Request for Cost Estimate: ABANDON WELL

Doug's Tire (now Flambeau Auto)

Meridian No. 05F786

Subject: Change Order: Abandon Extraction Wells EX-2, EX-3, EX-6, EX-8, EX-9
Doug's Tire Center (former)
Ladysmith, Wisconsin
PECFA # 54848-1215-11-A
DNR BRRTS # 03-55-000408
Meridian No. 05F786

EXTRACTION WELL #2

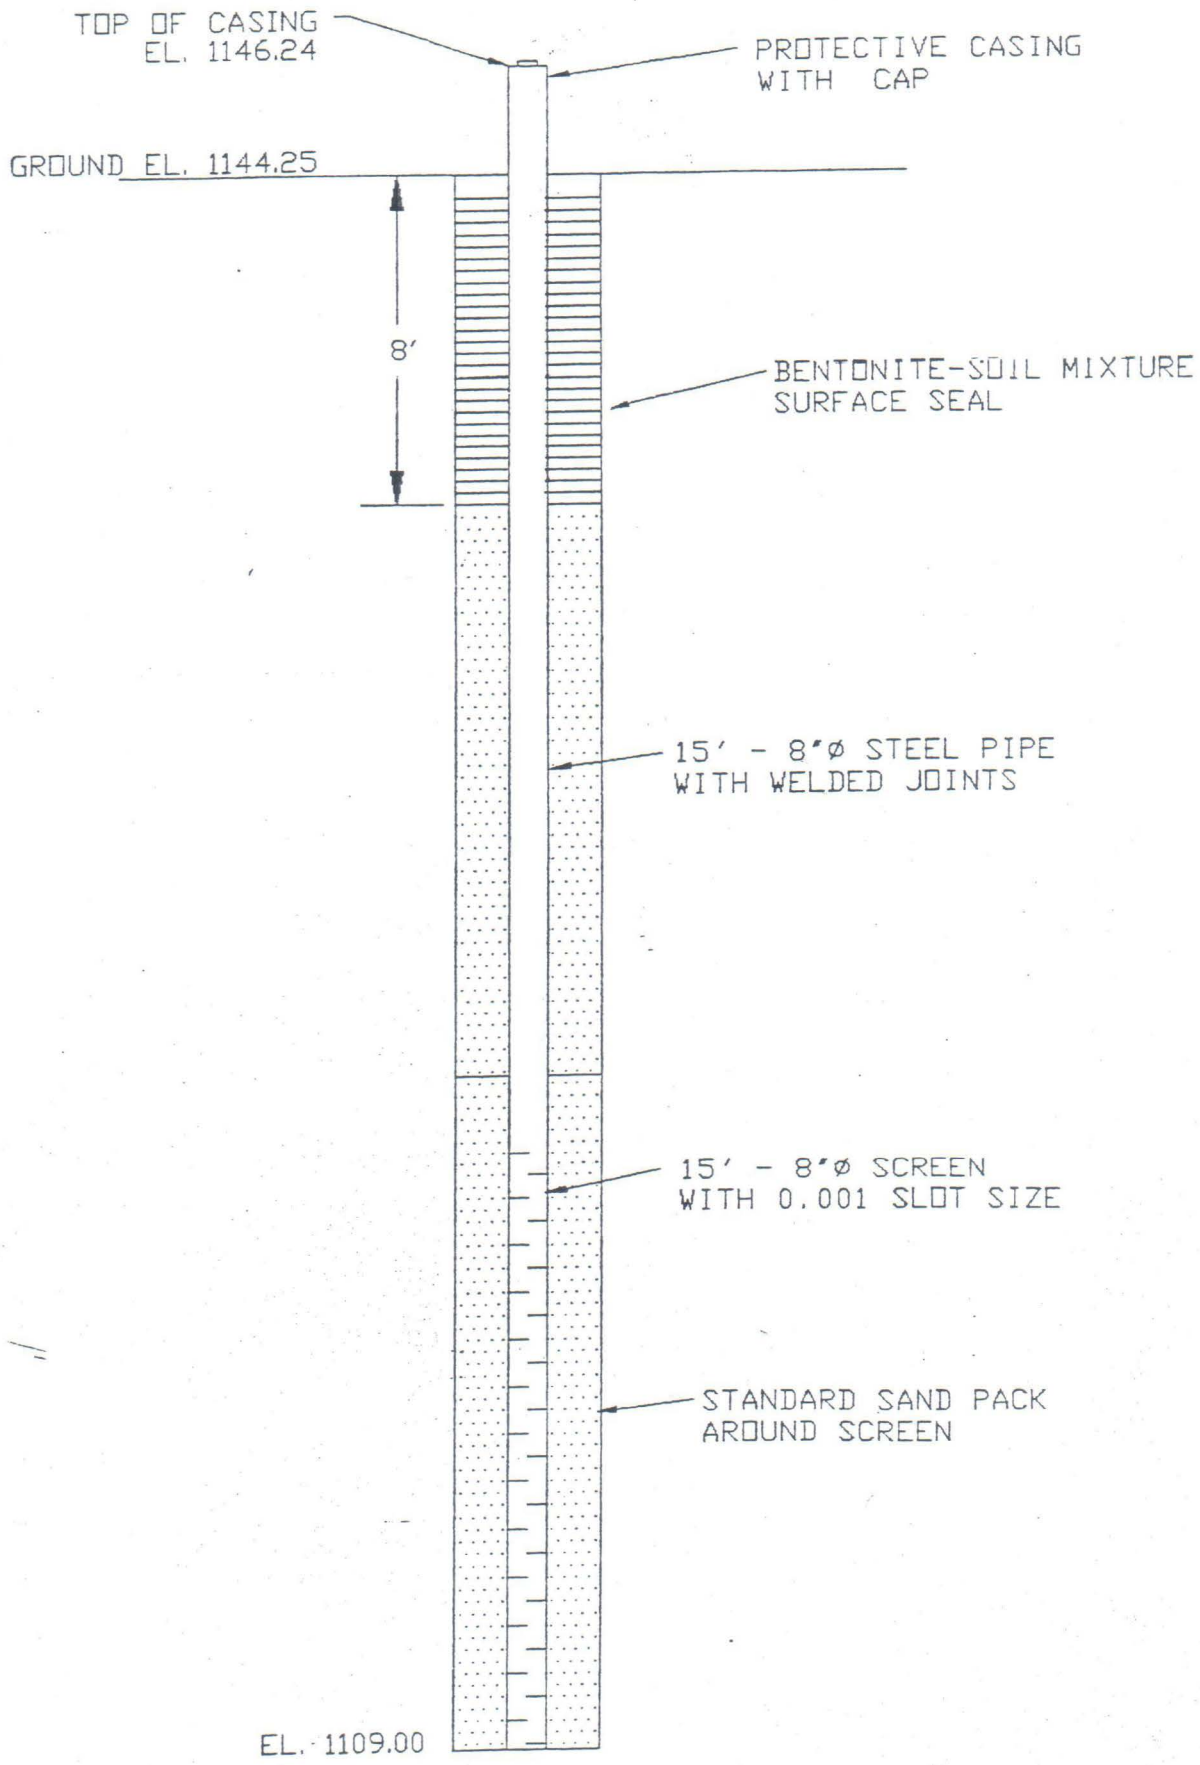
Abandonment of EX-2 will require a local contractor excavate to a depth of 4 feet and cut-off the 8-inch diameter well casing 4 feet below grade. The excavation will be compacted as it is backfilled to grade. A variance will be required for this cost.

Use mini-excavator to dig down (4 ft) so well casing can be cut off. Estimate trench 6 ft x 3 ft x 4 ft deep.

Backfill excavation with road base material. Compact every 1 foot.
